# ***Nords Wharf Concept Plan***

*Part 3A Modification  
Assessment  
(MP 10\_0088 MOD 1)*

January 2020

**Figure 5** | Proposed subdivision layout

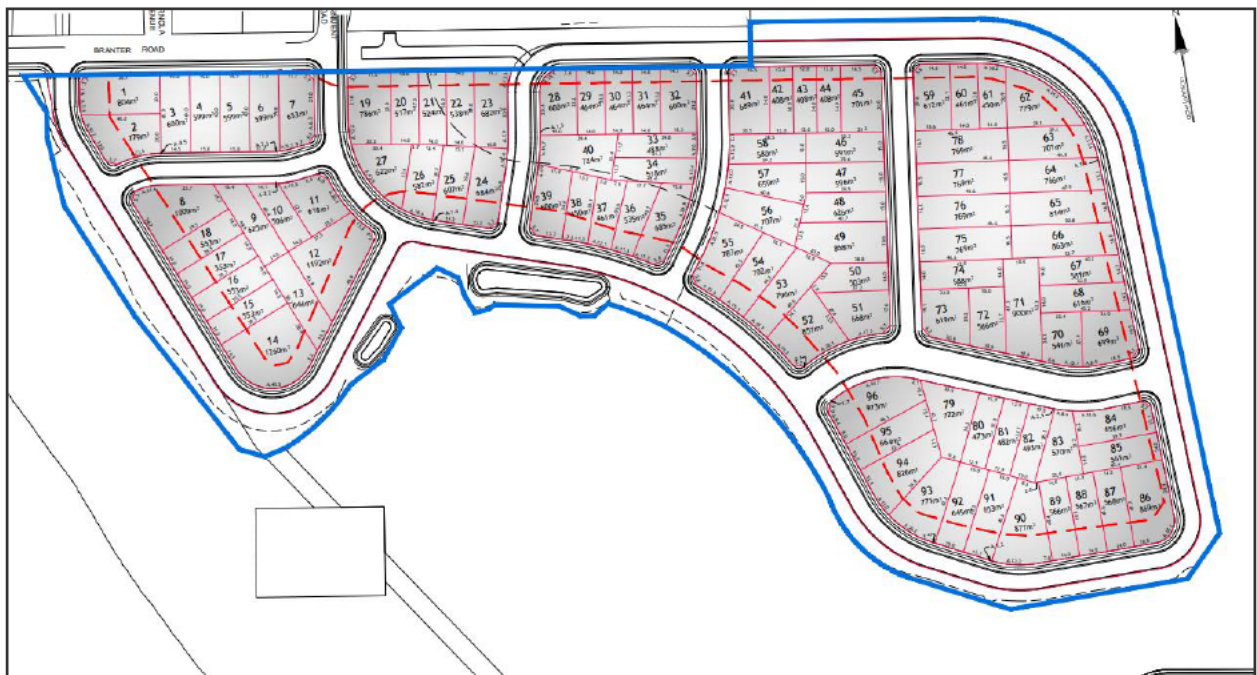
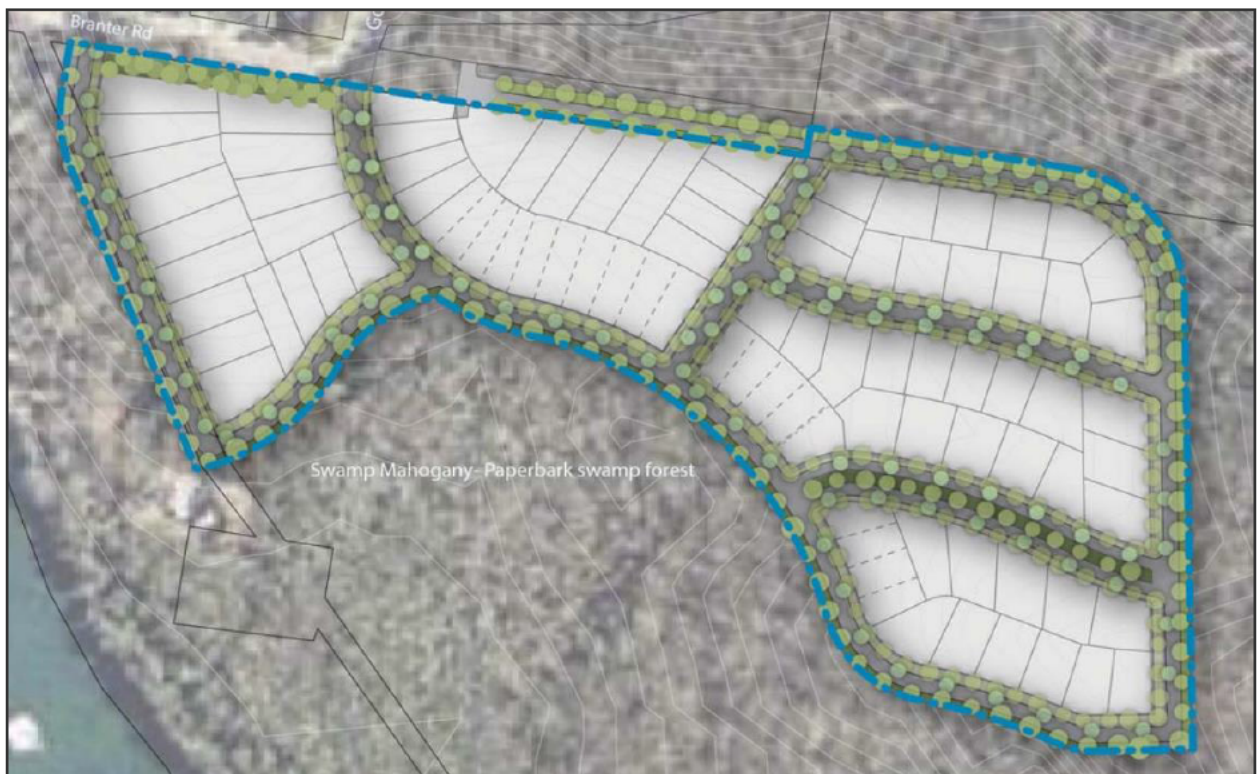
- Asset Protection Zones (APZs) should be located within the road reserve, which Council maintains, rather than extending into bushland which Council does not maintain

- the relocation of APZs in accordance with the above is likely to increase the area of APZs within residential lots, and result in building footprints within the BAL 40 area which is unlikely to be supported

- the Crown road reserve (proposed lots 301-306) has been approved to become a public road and not transferred to private ownership
- inadequate details about proposed cut and fill have been provided

- the impacts of the proposed intersection changes on the local road network have not been sufficiently addressed
- the approved layout includes large lots adjacent to the Branter Road landscape buffer and the proposed lot layout includes smaller lots which may have a negative impact on achieving the buffer

- the proposed modifications are inconsistent with the Urban Design Guidelines approved for the site.

Issue	Findings	Recommended Condition
<i>Subdivision layout</i>	<ul style="list-style-type: none"> <li>• The proposal seeks to modify the subdivision layout to increase the number of lots from 90 to 96.</li> <li>• The Department considers the proposed subdivision layout is acceptable as:               <ul style="list-style-type: none"> <li>○ the majority of lots meet the minimum lot size of 450m<sup>2</sup> and lot width of 14m in accordance with the Lake Macquarie LEP 2014</li> <li>○ the battle-axe blocks, proposed as part of the original modification request, have been removed</li> <li>○ it would contribute to the provision of additional housing in the Hunter region in accordance with the regional plan.</li> </ul> </li> <li>• The Department also notes that the proposal relates to a concept plan, therefore the layout is indicative only, and the design will be finalised as part of future DAs assessed by Council.</li> </ul>	Modified Condition 1.4 stating that the approved subdivision plan is indicative only.

**Figure 8** | Proposed intersection design

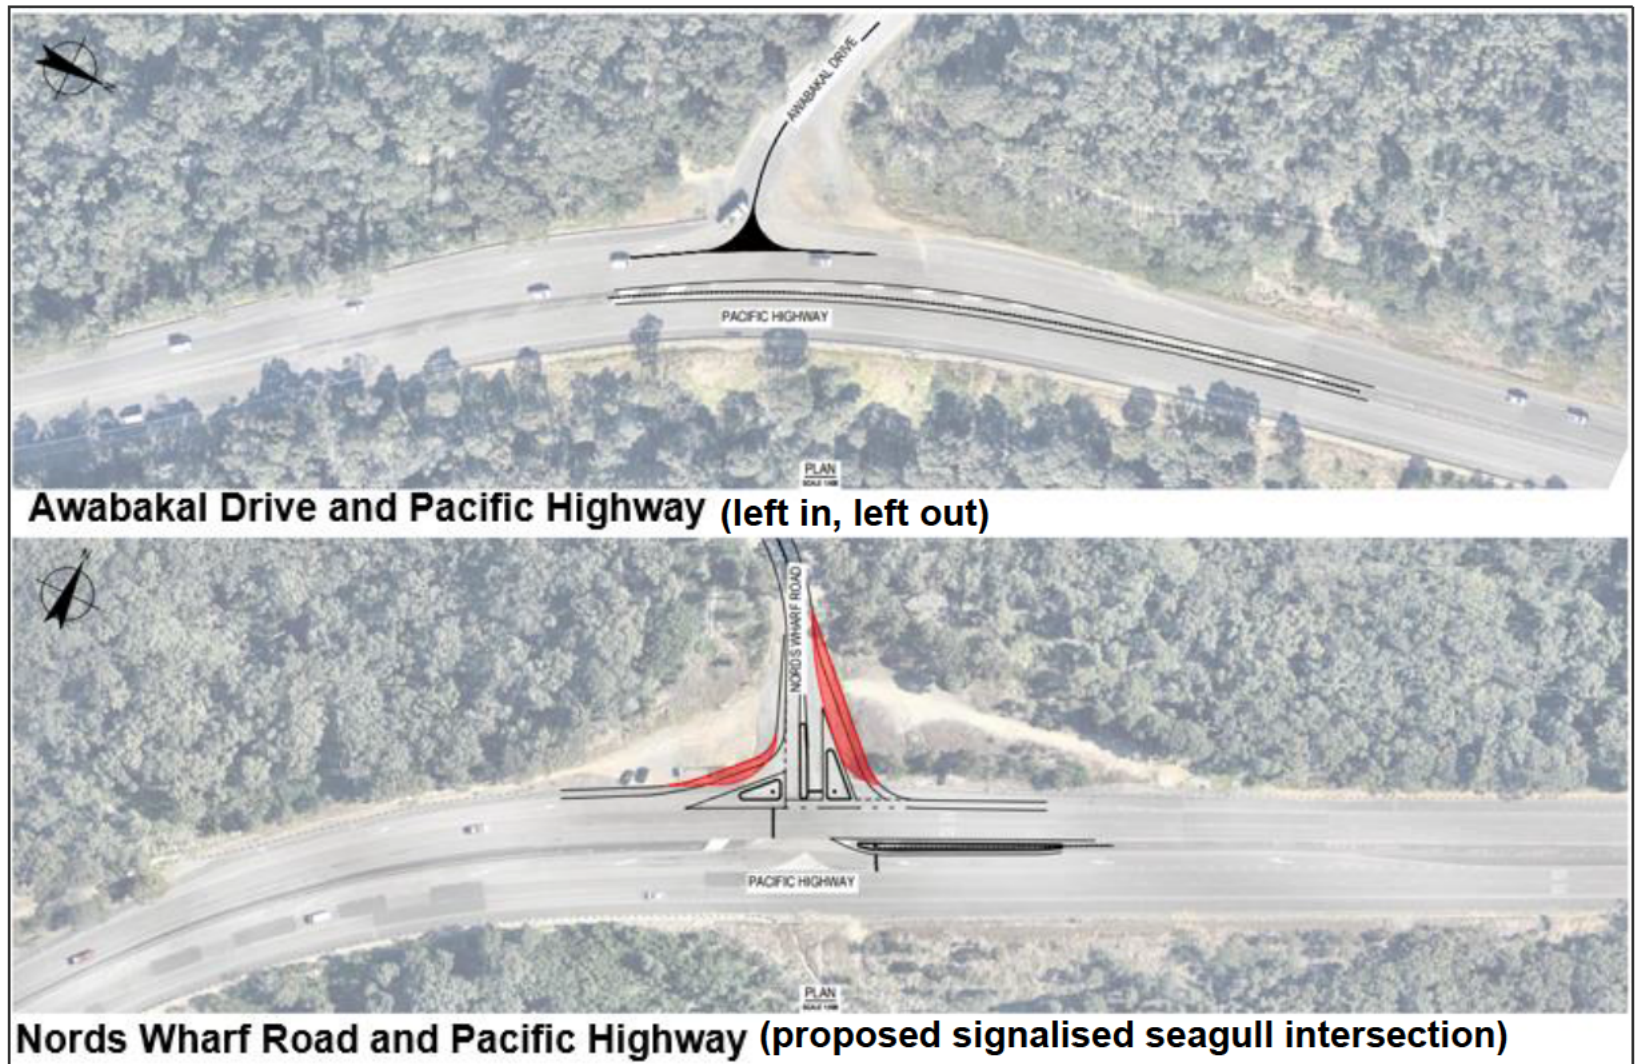
6.2.1 The proposal seeks to change the intersection of the Pacific Highway and Awabakal Drive to left-in, left-out only, and modify the intersection of Nords Wharf Road and the Pacific Highway to a signalised seagull intersection (as summarised in **Table 6** and outlined in **Figure 8**).

6.2.6 Based on the advice of RMS, the Department acknowledges that either option could provide a safe and efficient outcome in relation to the ingress and egress from the Pacific Highway. However, following a review of all environmental impacts and consultation with the community, the Department does not support the proposed changes to intersections.

6.2.7 The Department notes that the proposal would alter the local road traffic flows in the area, as residents wishing to travel south along the Pacific Highway would need to travel north along a local road (Government Road) to use the Nords Wharf Road intersection (**Figure 7**). This would increase the amount of traffic on local roads and inconvenience residents (particularly those in the south of Nords Wharf).

6.2.8 The Proponent submitted a Traffic Impact Assessment (TIA) as part of the modification request, stating that an additional travel time of 2 minutes for 20% of residents would be incurred as a result of the proposed changes. However, RMS disagrees and notes it is likely that more than 20% of residents would be affected, as the distribution diagrams do not consider that people are likely to use the closest intersection.

- 6.2.15 The Department has considered the impacts of the proposal on the local roads and existing and future residents of Nords Wharf and consulted with the local community. While RMS noted that both options could provide an acceptable safety and efficiency outcome, the Department does not support the proposed intersection changes, and considers the retention of the approved arrangement is appropriate as:
